BUILDINGS ORDINANCE (Chapter 123)
(Section 35)

BUILDINGS ORDINANCE (CAP. 123)
Order by the Building Authority under section 24(1)

Order No.:	UBCSN/06-16/0003/13	Office of the Building Authority 12/F - 18/F., Pioneer Centre, 750 Nathan Road, Mongkok, Kowloon.
BD Ref.:	MBU/9110/72/C04(CR/13)	Date: 23 March 2018
To:	The owner of Block B on 1/F & Car Port No.4 on G/F Mandel Villa, 683 Clear Water Bay Road, Sai Kung, New Territories

Plan annexed to Order No. / 此圖則附連於命令編號 : UB CSN/06-16/0003/13

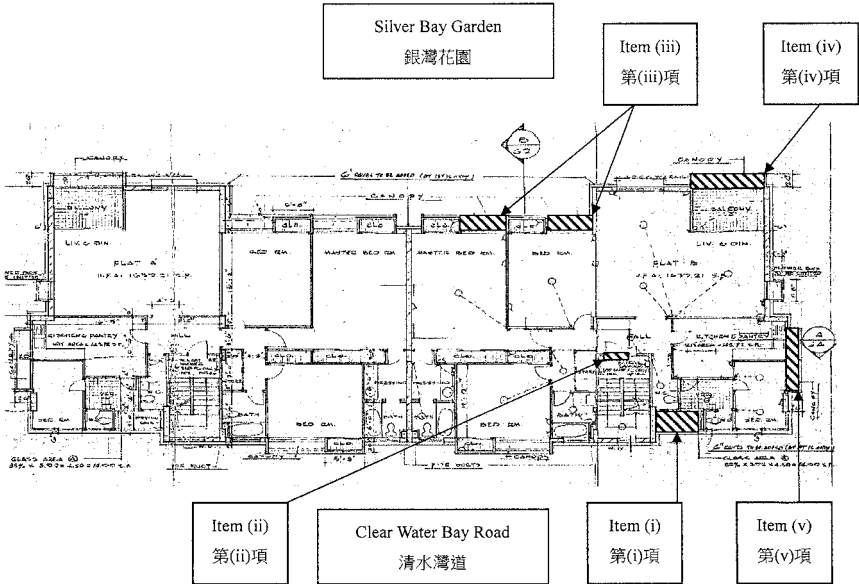
1. It has been brought to my attention that the following building works have been carried out in or at the above premises:
 - (i) 1 no. of structure erected at the area of drying rack facing Clear Water Bay Road;

- (ii) Swing outward metal gate was installed at the unit entrance;
 - (iii) 2 nos. of bay windows erected at the approved canopies facing Silver Bay Garden;

- (iv) Glass window wall erected on the approved canopy facing Silver Bay Garden;
 - (v) External wall and window erected on the approved canopy facing Mandarin Villa.
(The location of the building works described above are shown by item numbers on the 1 annexed plan, for purpose of identification only.)

2. For the said building works:
 - (a) The building works at items (i), (iii) to (v) above has been carried out without having first obtained from me the approval of building plans and consent for the commencement of such building works required by section 14 of the Buildings Ordinance.

- (b) As a result of the building works at item (ii) above, Regulation 41(1) of the Building (Planning) Regulations, which requires the building to be provided with such means of escape in case of emergency as required by the intended use of the building has been contravened.

3. In exercise of the powers vested in me under section 24(1) of the Buildings Ordinance, I hereby order you to :-
 - (a) demolish the said building works described under items (i), (iii) to (v) above; and

- (b) reinstate the parts of the building so affected by the building works under items (i), (iii) to (v) above in accordance with the plans approved by the Building Authority/ minor works completion record submitted to the Building Authority.

- (c) alter the building works described under item (ii) above to such a condition to put an end to the contraventions stated in paragraph 2(b) above.
